MONTGOMERY COUNTY PLANNING DEPARTMENT
THE MARYLAND-NATIONAL CAPITAL PARK AND PLANNING COMMISSION

Way Station: Conditional Use Request for Residential Care Facility for 9-16 Persons

Completed: April 3, 2020

Staff Recommendation: Approval with conditions

Figure 7: Parking Waiver Exhibit

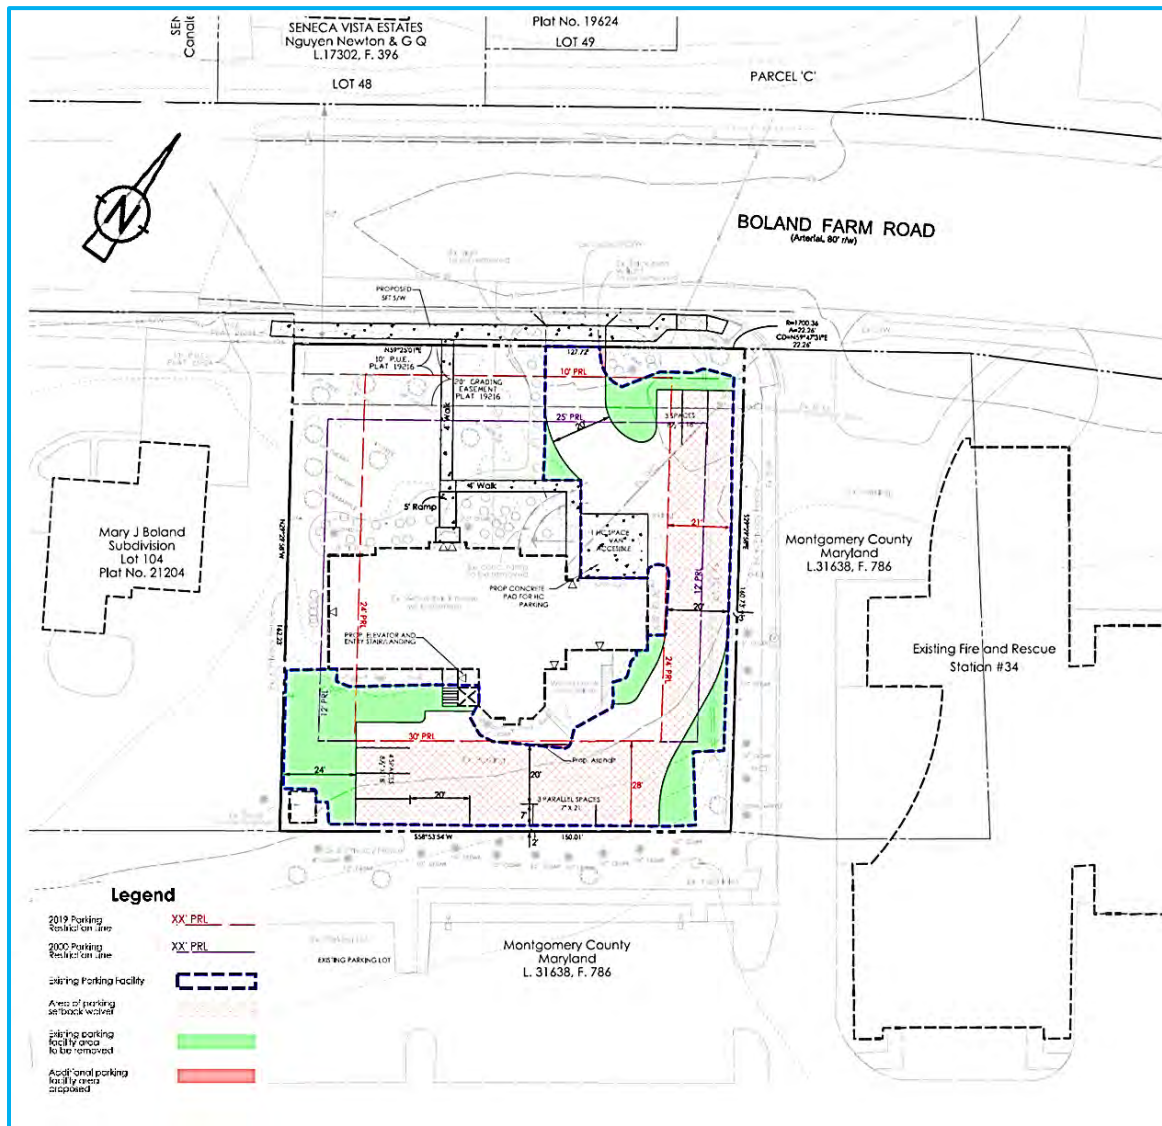
All proposed seven spaces in the rear yard are positioned entirely hidden from views from adjacent properties.

Moreover, these parking spaces abut a parking facility of the adjoining Fire Station which has a minimum of 20 feet wide set back that includes a row of mature Leyland Cypress (erroneously identified as Cedar trees on the plan) that provide screening of the Fire Station from the subject property.

The eastern side yard and the rear yard have been paved with asphalt and used as a driveway and parking lot for at least six years. Most of the asphalt paving was installed in violation of the previous Conditional Use S-2415. However, the current proposal to modify the asphalted areas will allow an organized internal circulation system while providing the required parking spaces thereby, reducing potential on-street congestion near and on the property. Moreover, the proposal will increase landscaping and trees,

Staff supports this waiver because the proposed driveway access point provides for the safest and most efficient access to the site while also using the existing driveway apron to access parking spaces in the rear portion of the property. As noted, the subject property abuts Fire Rescue Station No.34 on both its eastern and southern (rear) property lines (Figures 7 and 8).

Exhibit 10: Proposed Tree Save Plan

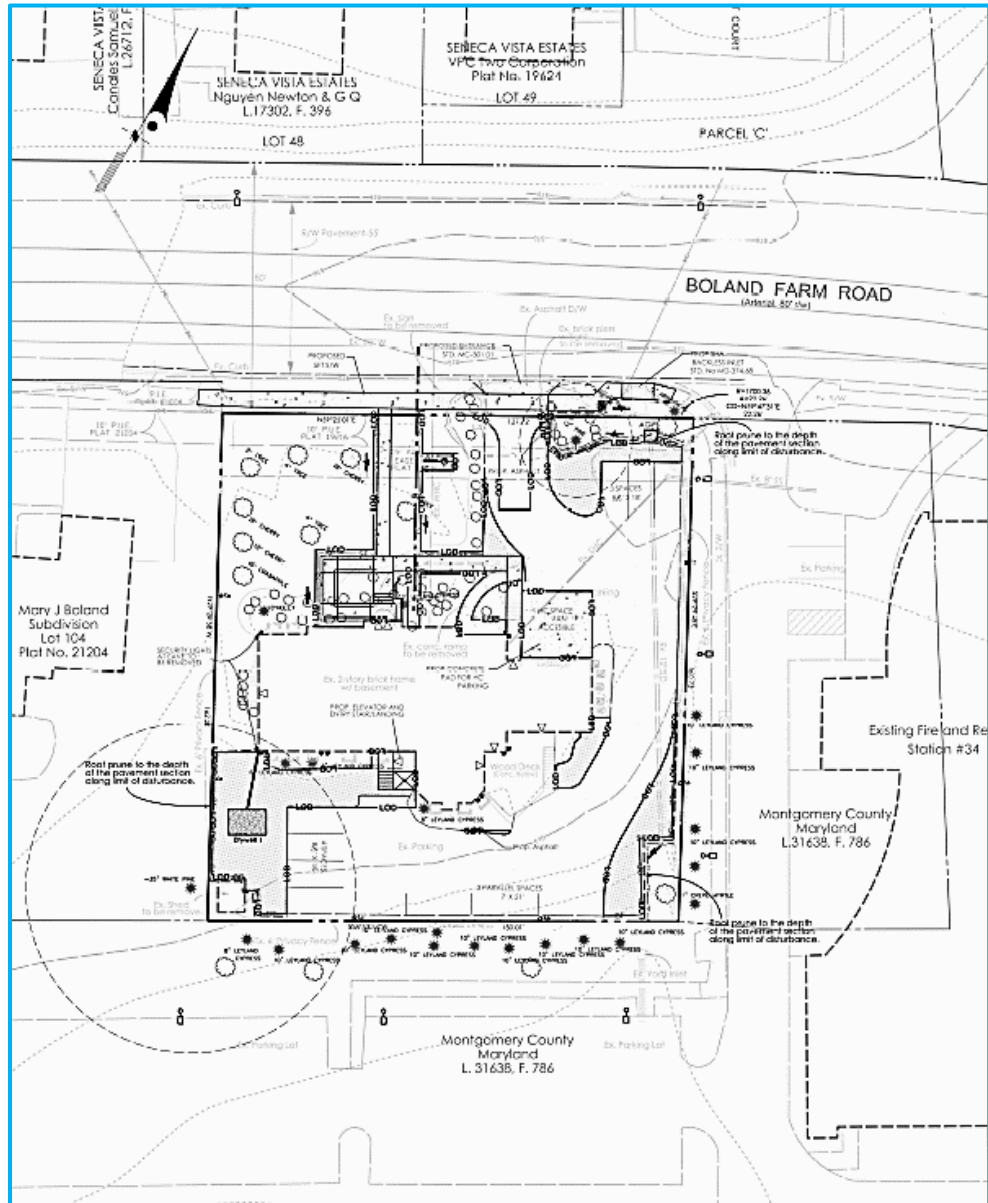
In supplemental submission the Applicant stated that the revision to the Tree Save Plan are a function of the recent changes made to the Conditional Use Site Plan and the Landscape and Lighting Plan. The applicable revisions include:

- Added a new ramp by the front door for ADA access.
- Some minor graphic clarity improvements (made existing lights less prominent and corrected label of existing Cedars to Leyland Cypress on Fire Dept. property)

The Limit of Disturbance (LOD) was adjusted to reflect these changes to the proposed site improvements. Please see the Landscape and Lighting Plan for information regarding the proposed plantings.

Staff recommends approval of the revised Tree Save Plan.

Figure 11: Conditional Use Plan (Attachment A)

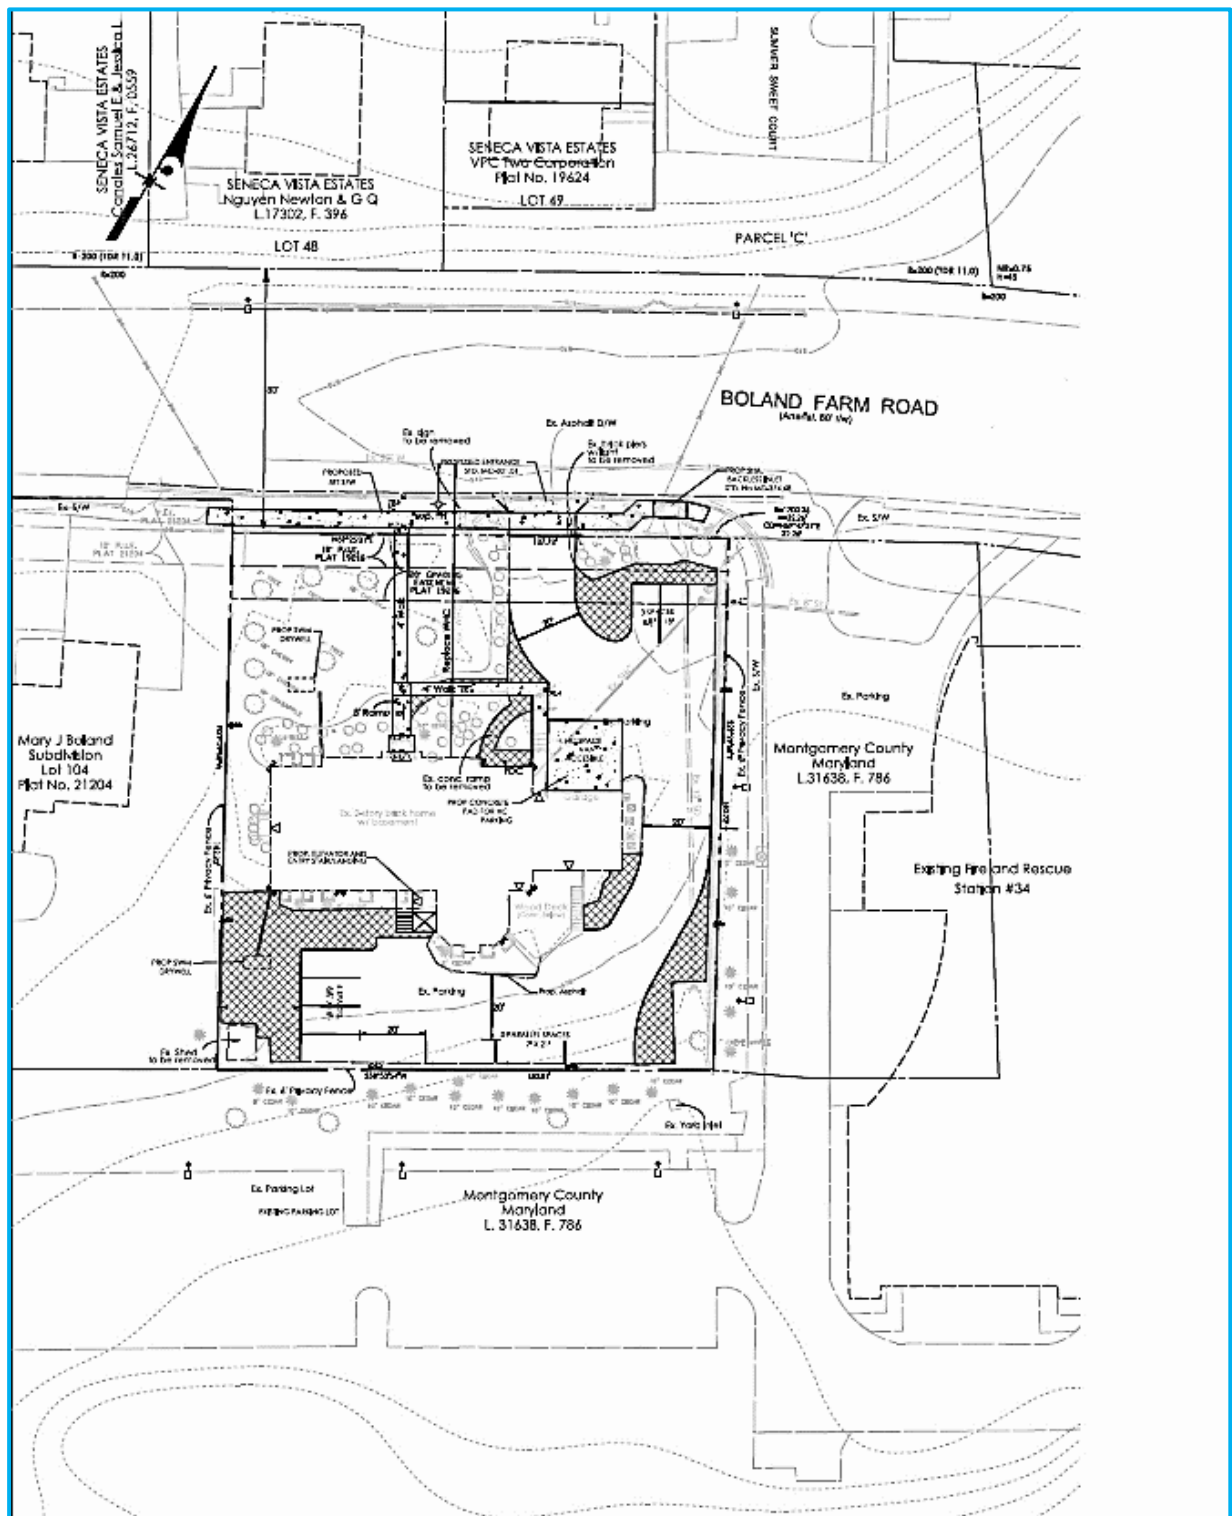
The Conditional Use Plan shows a four-foot lead walkway providing pedestrian access from Boland Farm Road to the Residential Care Facility. The Applicant must provide marked crosswalks from the drive aisle/parking lot to the building front and rear entrances to provide safe and adequate pedestrian access for residence.

3. An identification sign must not be placed on the property.
4. The Applicant must provide marked crosswalks from the drive aisle/parking areas to the building front and rear entrances.

LANDSCAPE & LIGHTING PLAN for Conditional Use

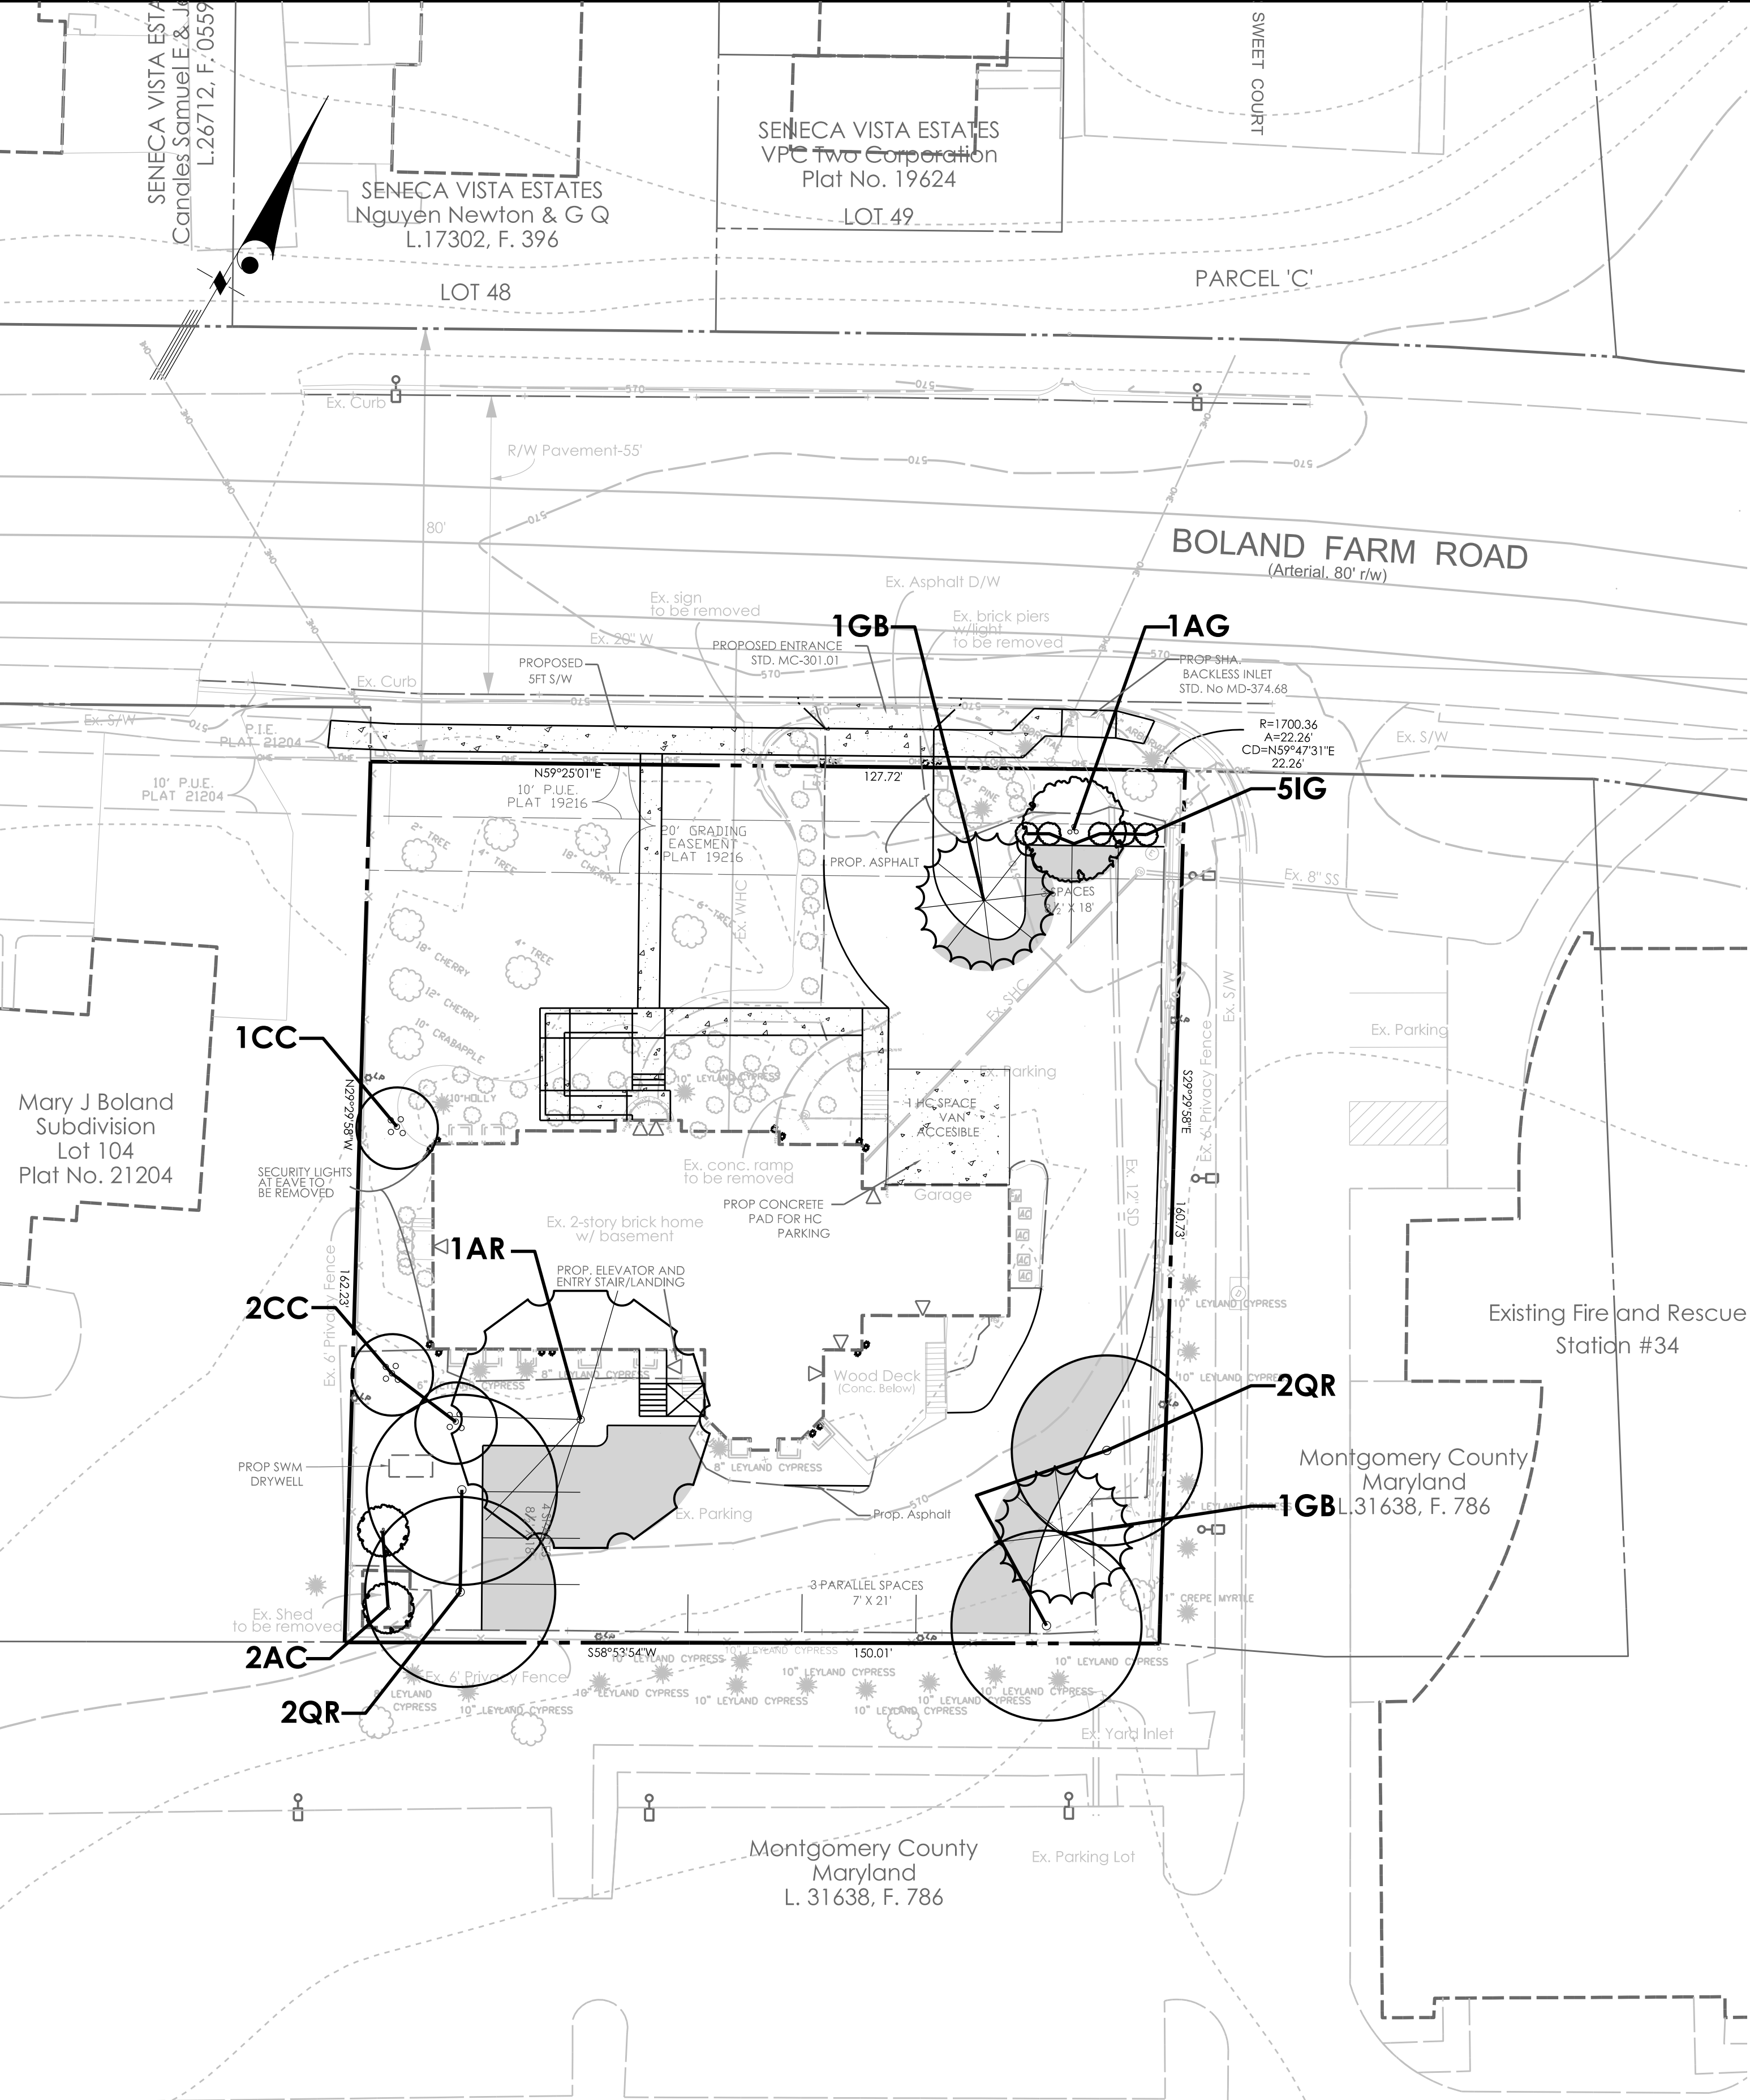
In response to staff's suggestion, the Applicant has revised the Landscape and Lighting Plan adding additional planting on the northwest corner of the building. The proposed and existing trees in the front yard, will help to minimize and mitigate potential impacts of glare and noise on the adjoining property to the west.

For the small parking area in the southwest corner of the project, the Applicant is proposing to provide enhanced screening in the form of three overstory trees, two understory trees, and two large shrubs, in addition to the existing six-foot privacy fence surrounding this area. The application meets or exceeds the screening requirements under Section 6.2.9.

No.	Revision	Date	By
1	Added Redbud, canopy coverage, and other misc. revs. based on staff comments.	3/15/20	DK

The submitted Landscape Plan revised on March 16, 2020 satisfies these requirements.
